Notice of Modification

The project approval (08_0101) granted by the Minister for Planning on 26 November 2010 for the Integra Underground Project.

APPENDIX 3: PROJECT LAYOUT PLANS

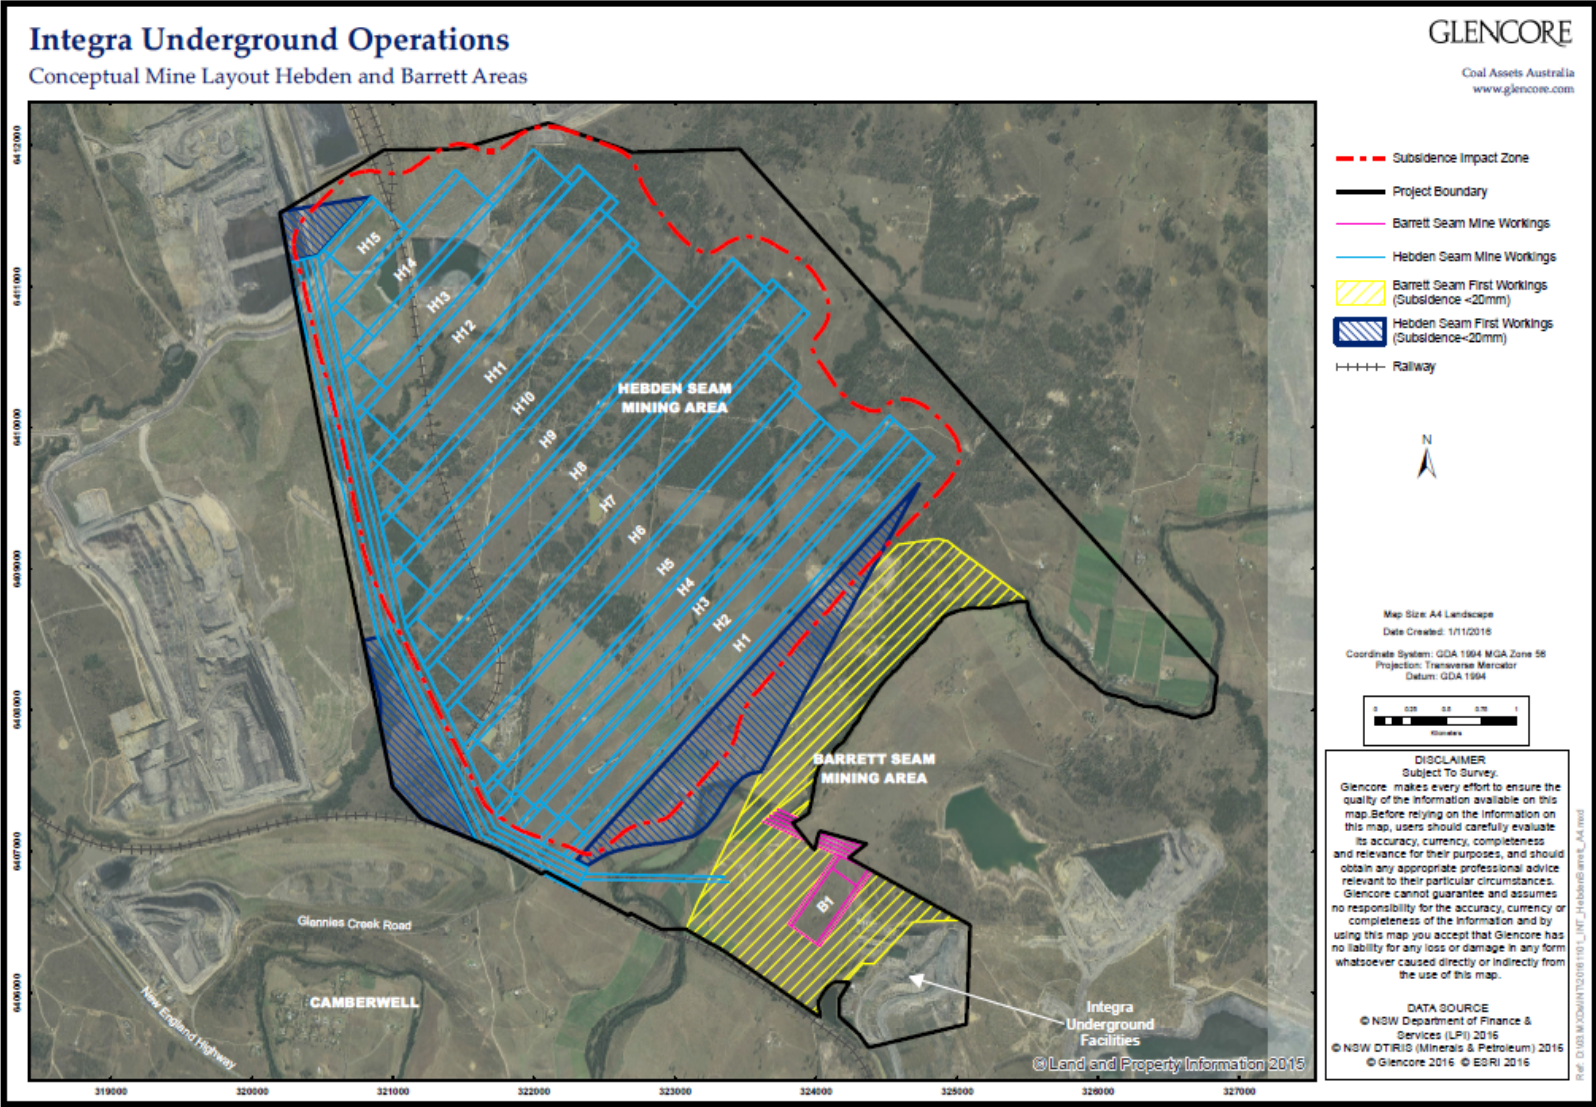
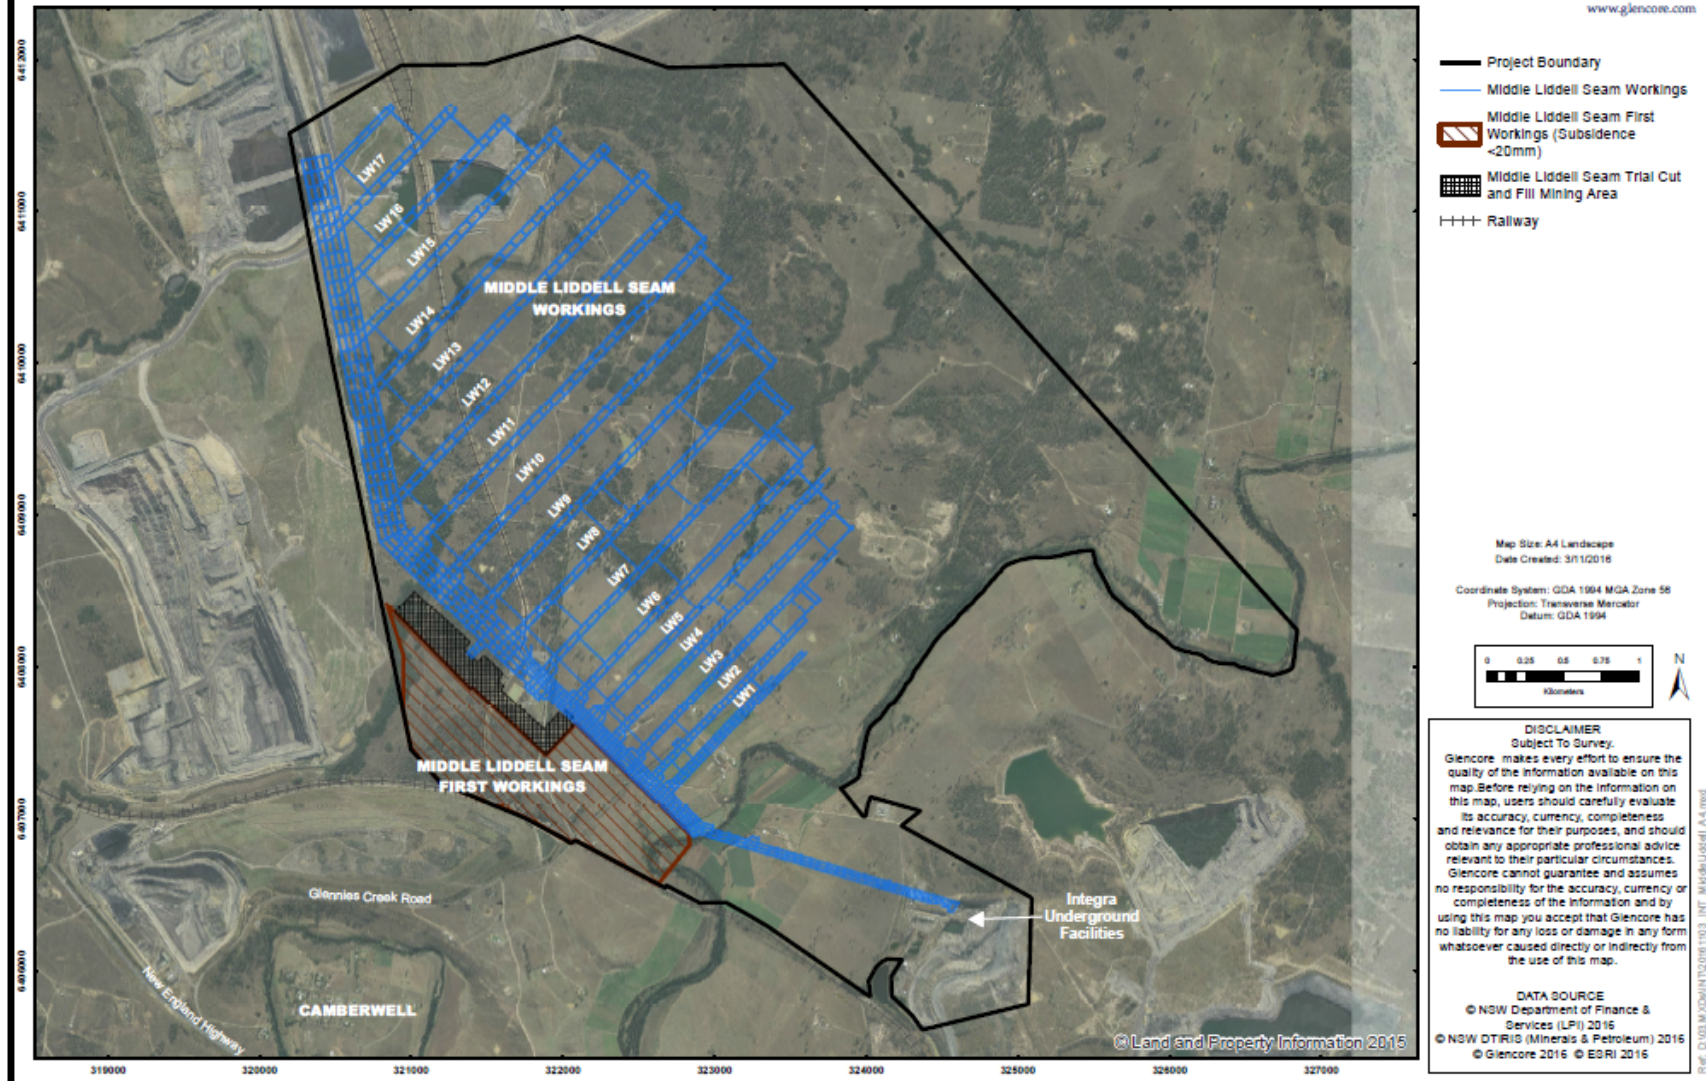
8. Delete Appendix 3 and replace with the following:
